**CITY OF NORTH ST. PAUL
PLANNING COMMISSION
REGULAR MEETING AGENDA
THURSDAY, OCTOBER 4, 2018
6:15 PM**

A. Anchor Block: Planned Unit Development, Preliminary Plat and Right-of-Way Vacation

Date: 9/27/2018
To: Planning Commission Members
From: Erin Perdu, AICP, City Planner
CC: Craig Waldron, Interim City Manager
Paul Ammerman, Community Development Director
Re: Planned Unit Development, Preliminary Plat and Alley Right-of Way Vacation for
Anchor Block Development

Figure 5: Right-of-way to be vacated

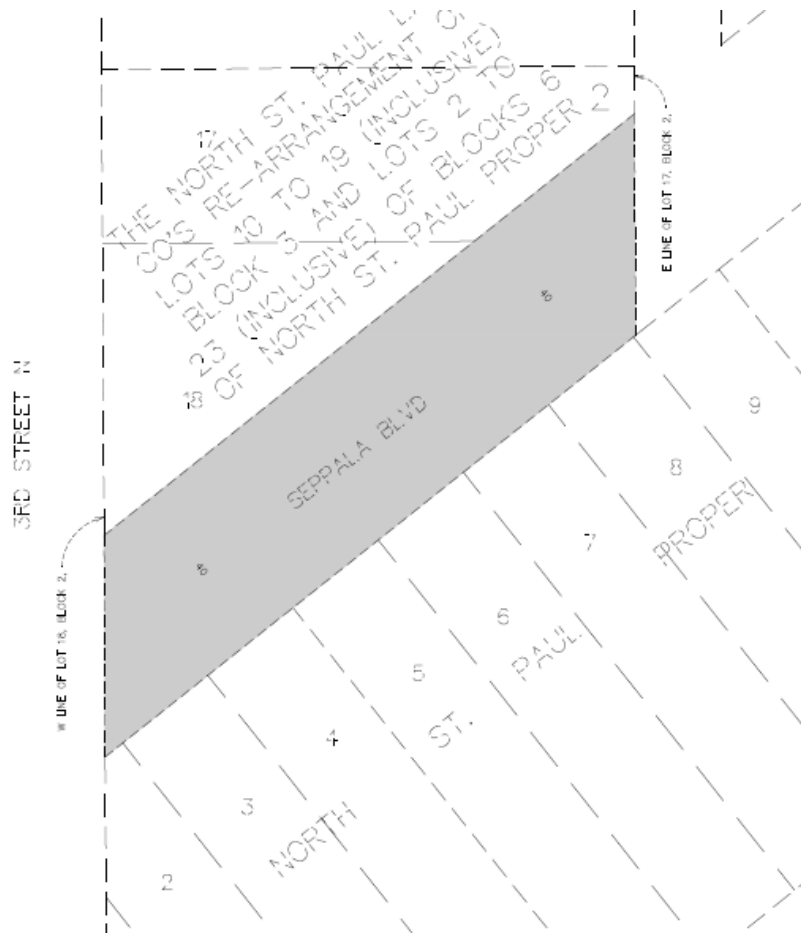
One portion of the undeveloped Seppala Boulevard right-of-way is proposed to be vacated as a part of this application. This right of way is unused by the City for transportation purposes. The applicants wish to use their portion of the vacated right-of-way for additional open space and grading/stormwater management.

The vacation will be contingent on easements being granted back to the City for access to all utilities.

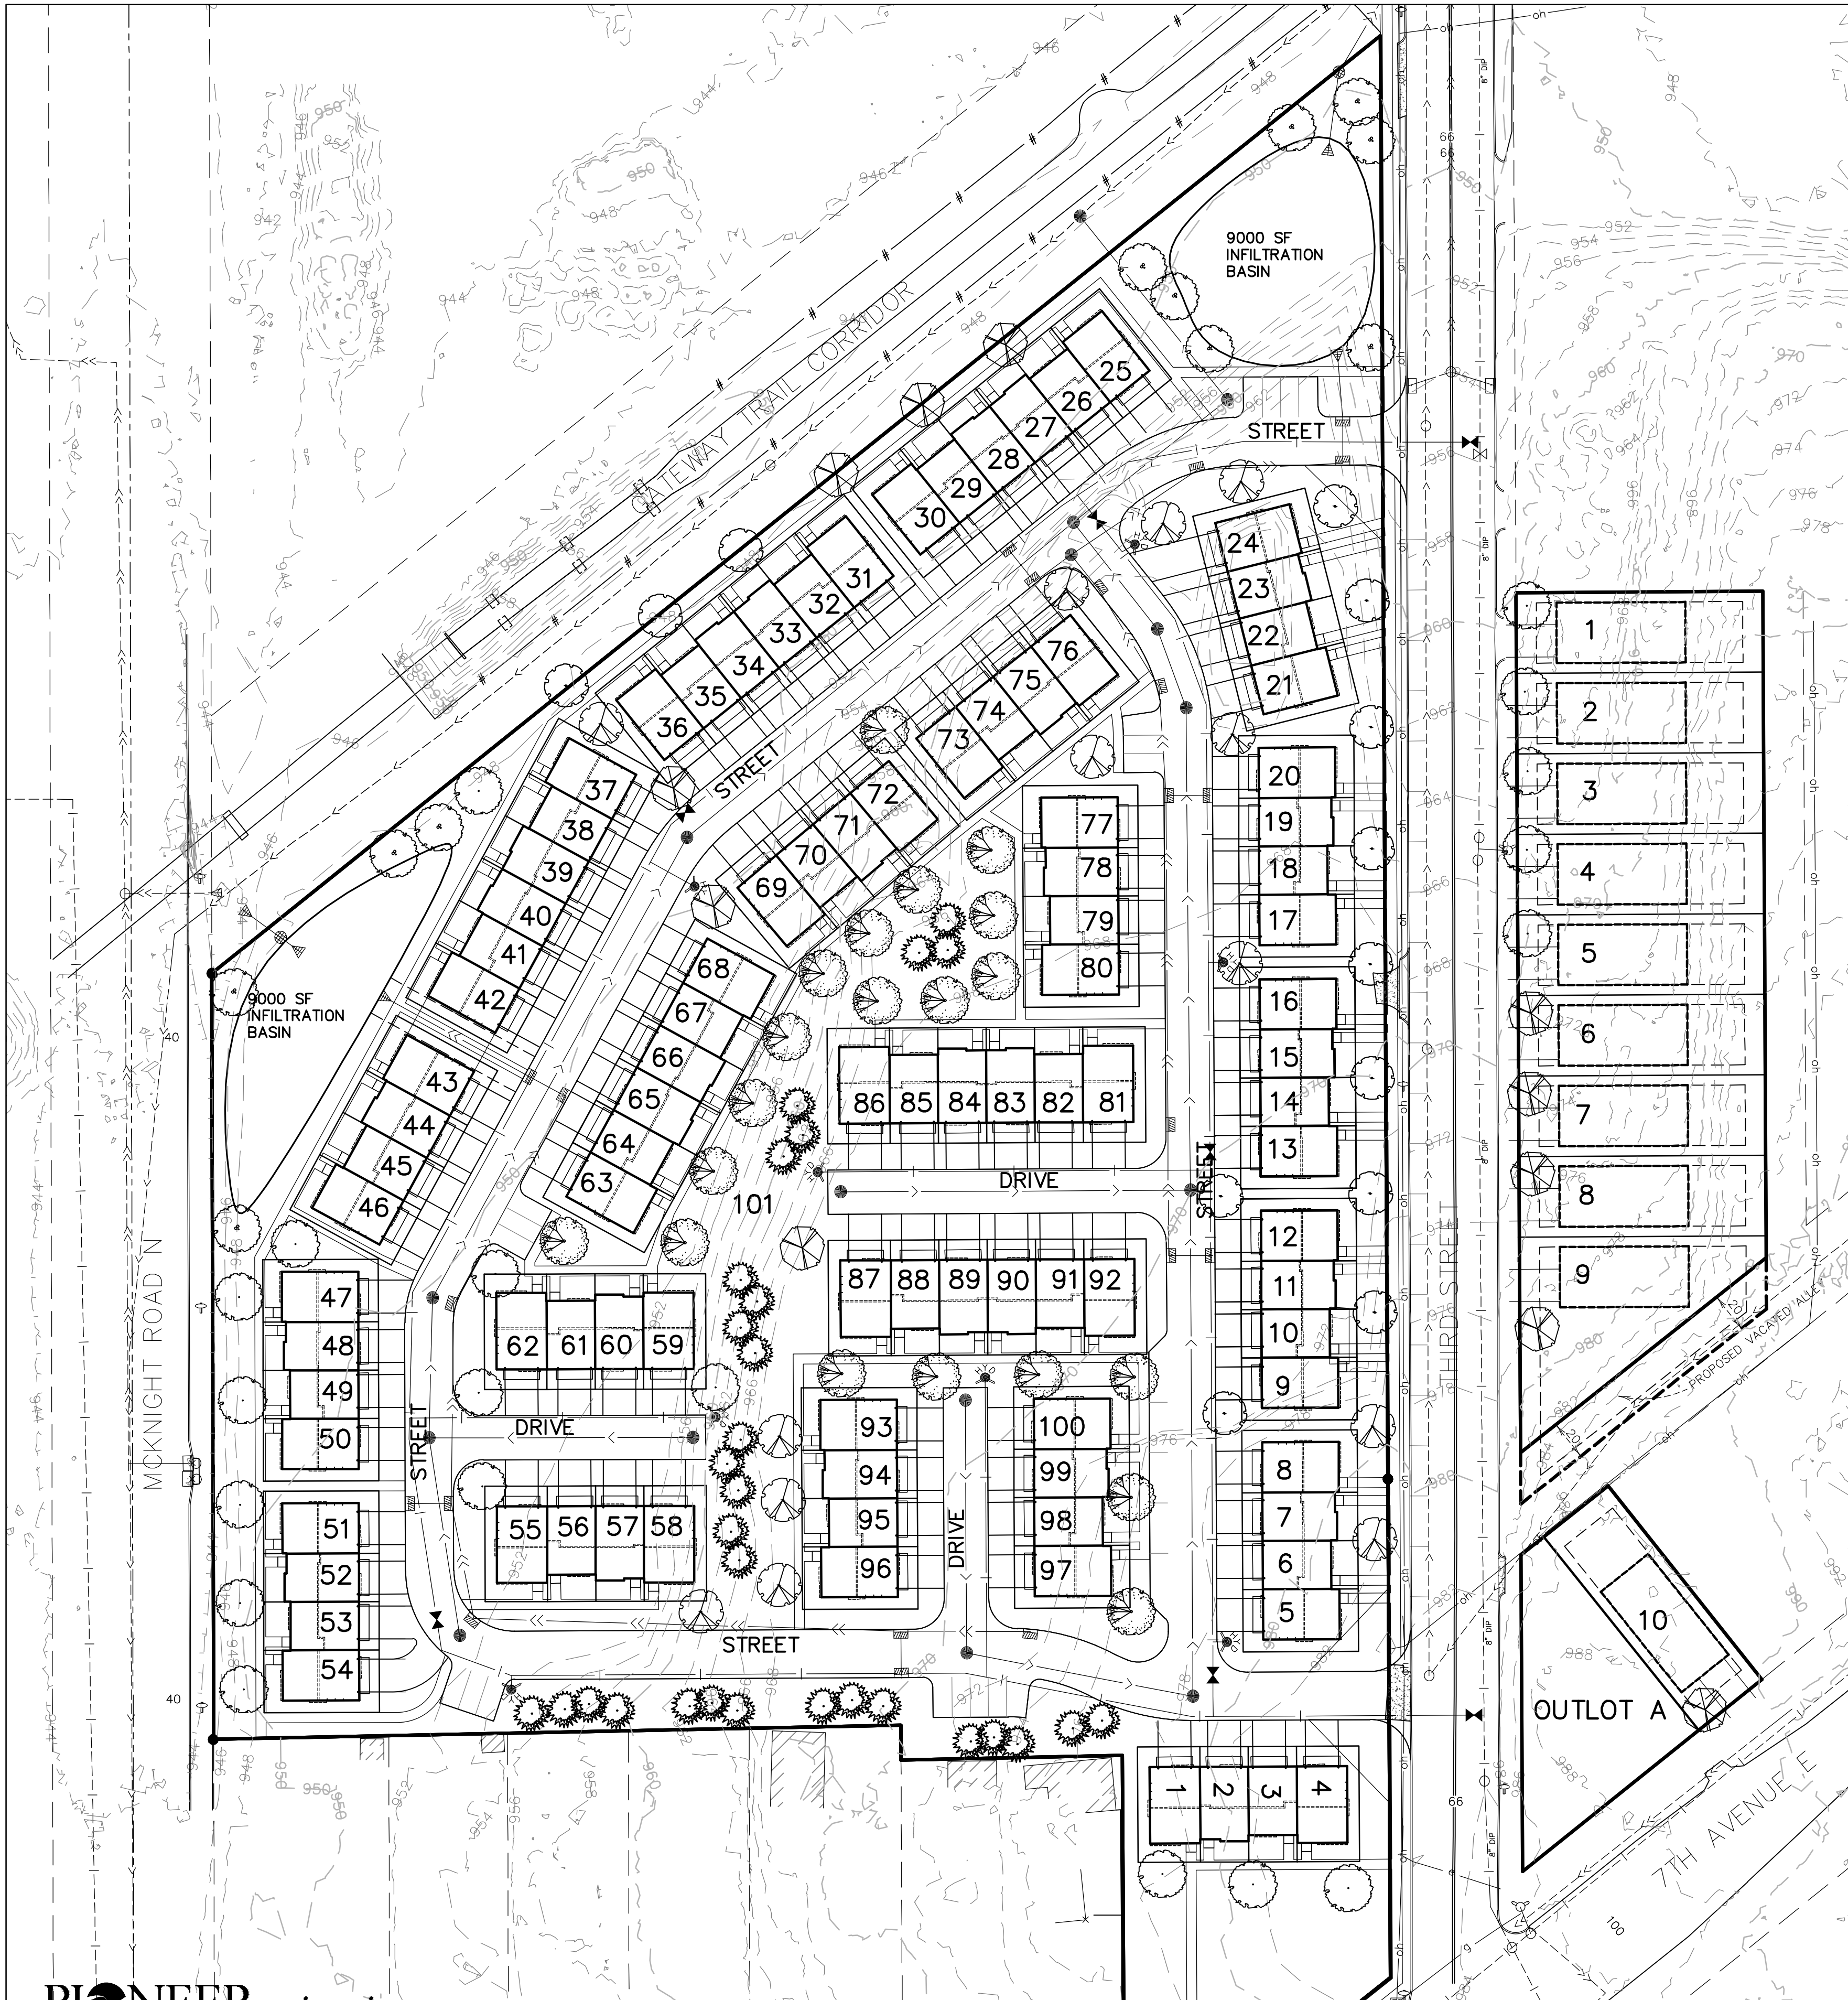
- c. The soil survey shows A soils throughout most of the property. However, the cross section of the infiltration basin on the storm sewer utility plan shows amended soils 18 inches below the surface. Applicant should consider leaving soils in situ if the soil borings confirm A soils are present at the location of the proposed infiltration basins. Update the design infiltration rate if applicable.

1. The current storm sewer utility plan shows the 18-inch outlet pipe from the northeast infiltration basin being routed into a 12-inch RCP outside of the property boundary. Applicant should reduce the size of the outlet pipe from the proposed infiltration basin to a 12-inch RCP so a larger pipe is not being routed into a smaller pipe. Applicant should confirm there is adequate capacity in the 12-inch RCP in 3rd Street to take the drainage from the basin outlet.
2. Applicant should add the invert elevation at Ex. STMH-64B for the outlet pipe from the northeast infiltration basin.

1. The outlet control structure (OCS) detail shown on the storm sewer utility plan sheet should be updated to represent what will be installed at the two infiltration basins. Either two details should be provided—one for each proposed OCS—or a table with specific elevations/pipe sizes/MH size should be provided with the appropriate information for each proposed OCS.

3. The emergency overflow (EOF) locations and elevations for the two proposed infiltration basins should be added to the storm sewer utility plan sheet and/or the grading plan sheet.

4. Pipe lengths and slopes should be added to the storm sewer utility plan.
5. The invert elevation for the existing flared end section outside the property lines in the northwest corner should be added to the storm sewer utility plan.

6. Riprap should be added to the storm sewer utility plan sheet at the flared end sections entering the infiltration basins.
